Flight connection shaft – INFORMATION BULLETIN

ECN ID #	ECN4510
DATE	June 4, 2024
BRAND	AGI, Westfield, Hutchinson, Mayrath, GrainMaxx
MODEL	13"/16" MKX2, HX2, X2, GrainMaxx Augers
DATE RANGE	April 2024 - present
DETAILS	Flight connection shafts

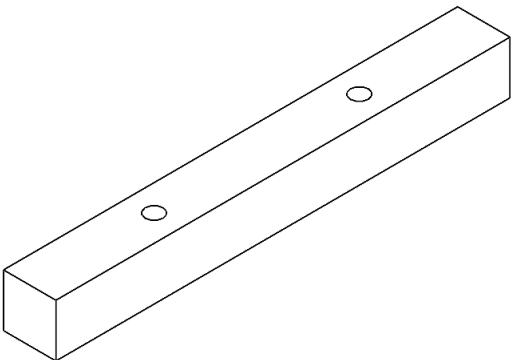
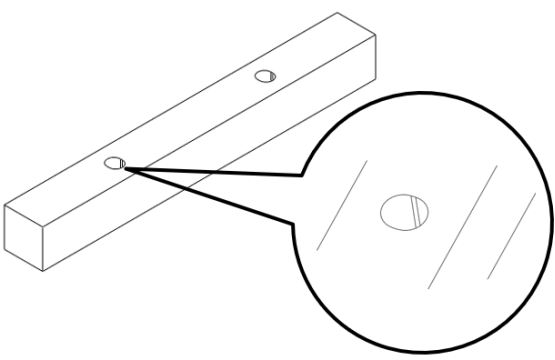
We have updated our flight connector shafts for performance enhancements. The table below summarizes the new and old part numbers.

Old flight connection shafts. 13" Augers PN: 29985 16" Augers PN: 10-20635	 New slotted hole flight connection shafts. 13" Augers PN: 203753 16" Augers PN: 203662
 Old boot flight connector shafts. 13" Augers PN: 202571 16" Augers PN: 202972	 New slotted hole boot flight connector shafts. 13" Augers PN: 203754 16" Augers PN: 203664

The new part numbers are backwards compatible with older MKX, X and HX augers.
